## Comparison of changes European PowerTOP-Plugs 16 and 32A

Page 1 of 1  
29/04/2003

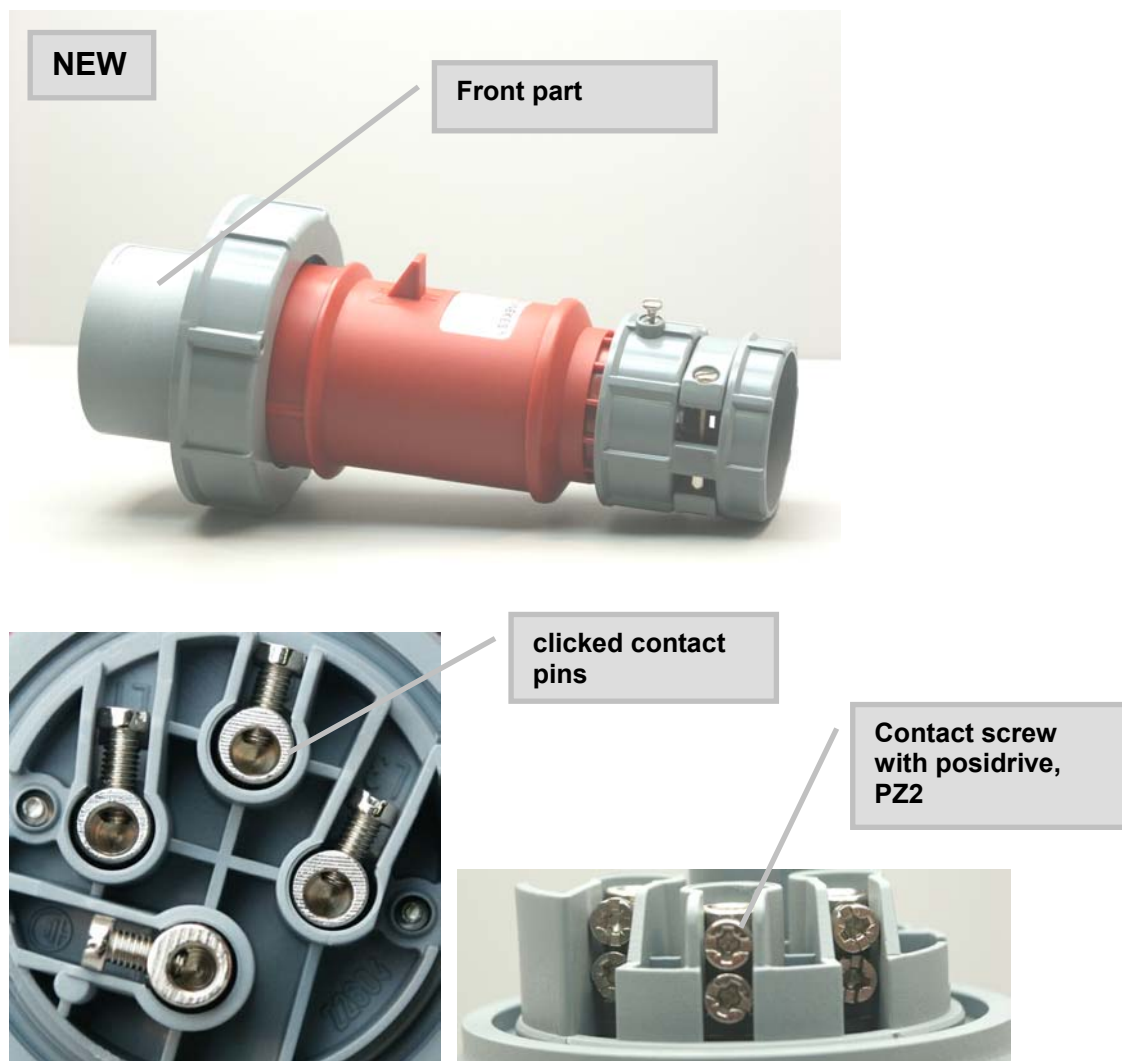
The changes concern only the corresponding front part of the plug.

The internal construction with insert and holding plate made of red brown material will be dropped. Instead, a front part of the plug with clicked contact pins, completely made of high heat resistant material is used (colour grey).

Complete front part of the plug made of high valued material, better accessibility of the terminals, universal contact screws.
